## REMARKS

Applicants have amended the drawings to show certain features of the invention specified in the claims. Applicants have amended the specification to mention reference numerals shown in the amended drawings and to correct a typographical error. Claim 9 has been amended to more particularly define the invention. No new matter has been introduced as a result of these amendments.

Appendix A - Annotated Marked-up Drawings

**FIG. 1**

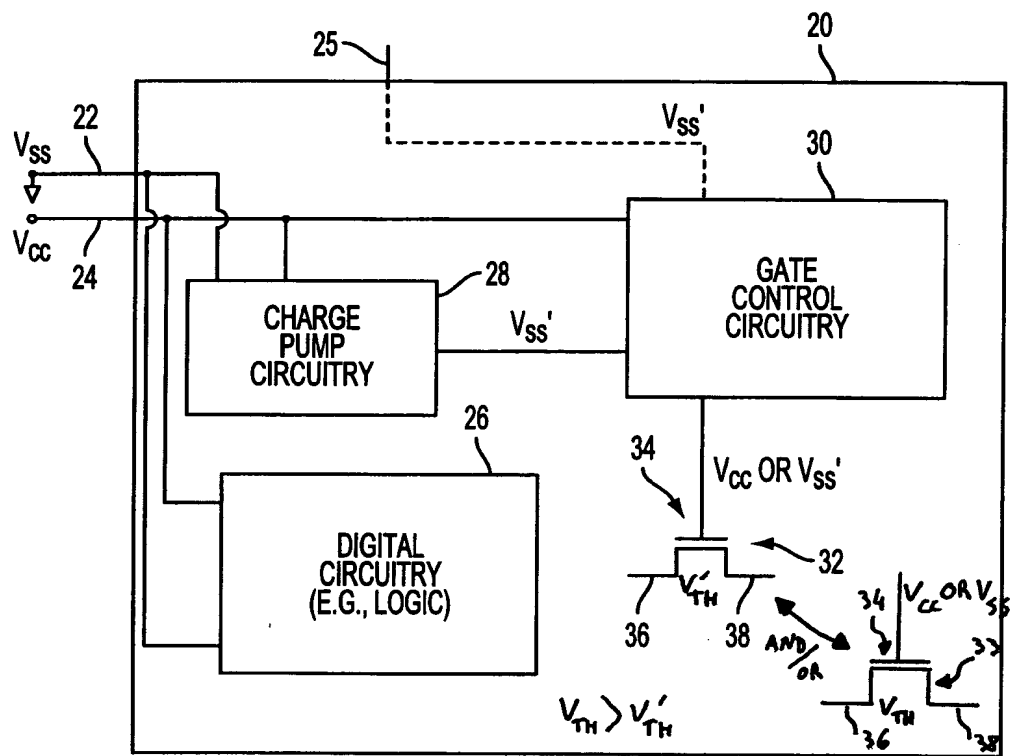
The Examiner contends that the feature "the additional transistors have higher threshold voltages than the plurality of transistors" specified in claim 15 is not shown in the drawings. Applicants have amended FIG. 1 to show transistor 33 that has a higher threshold voltage than transistor 32. Applicants have also amended the specification to reflect the amendments to FIG. 1.

Please approve the following amendments to FIG. 1 as indicated in red in the attached copies of the formal drawing for FIG. 1:

Add transistor 33.

Add text -- $V_{TH}'$ --, -- $V_{TH}$ --, -- $V_{TH} > V_{TH}'$ --,  
and -- $V_{CC}$  or  $V_{SS}$ --.

Add reference numerals --33--, --34--, --36--,  
and --38--.

FIG. 3

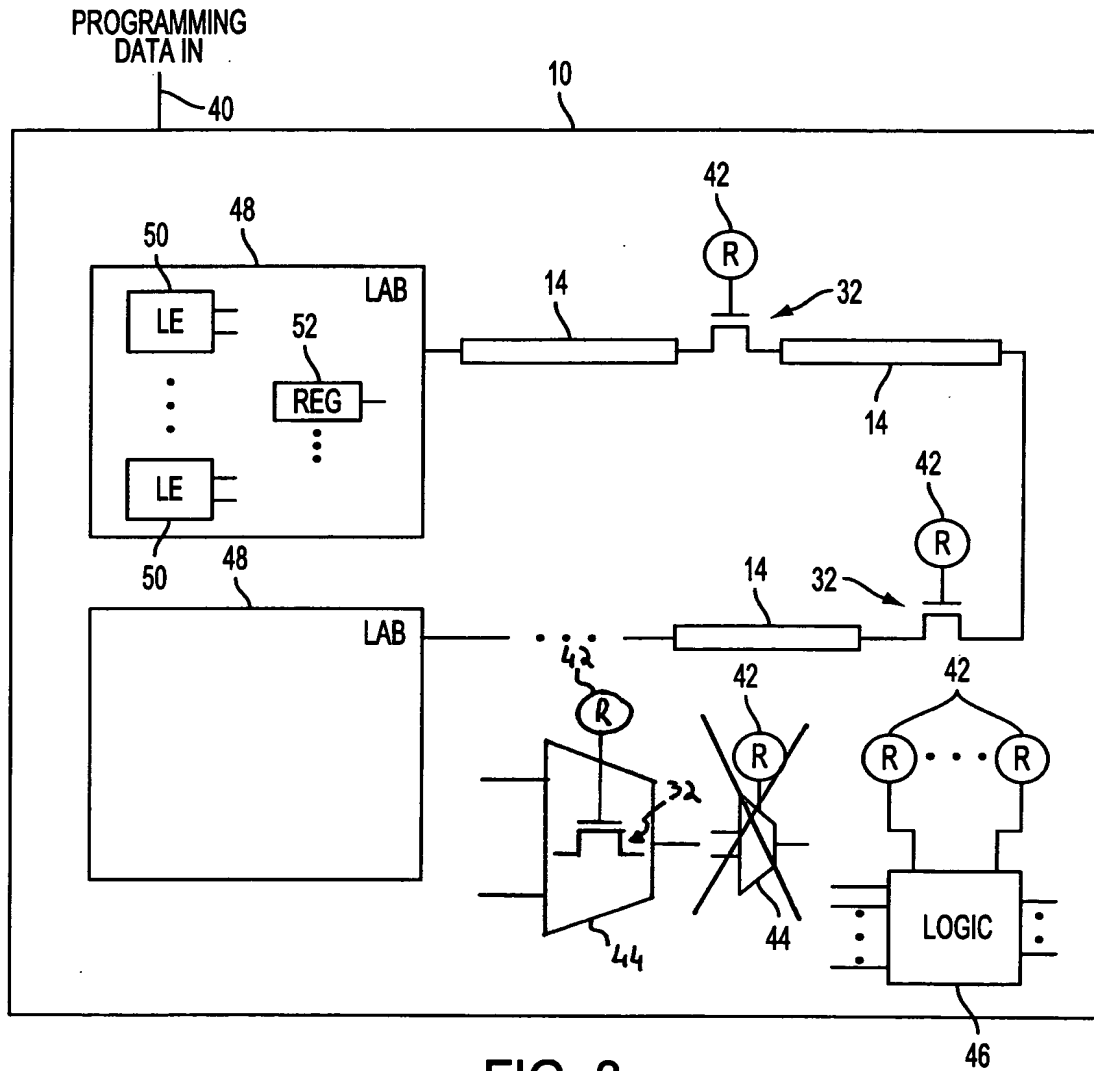
The Examiner contends that the feature "at least some of the transistors are included in the multiplexer" specified in claim 11 is not shown in the drawings. Applicants have amended FIG. 3 to show one embodiment of the invention in which at least some transistors are included in a multiplexer.

Please approve the following amendments to FIG. 3 as indicated in red in the attached copies of the formal drawing for FIG. 3:

Replace multiplexer 44 with amended version of multiplexer 44.

Add reference numeral 32.
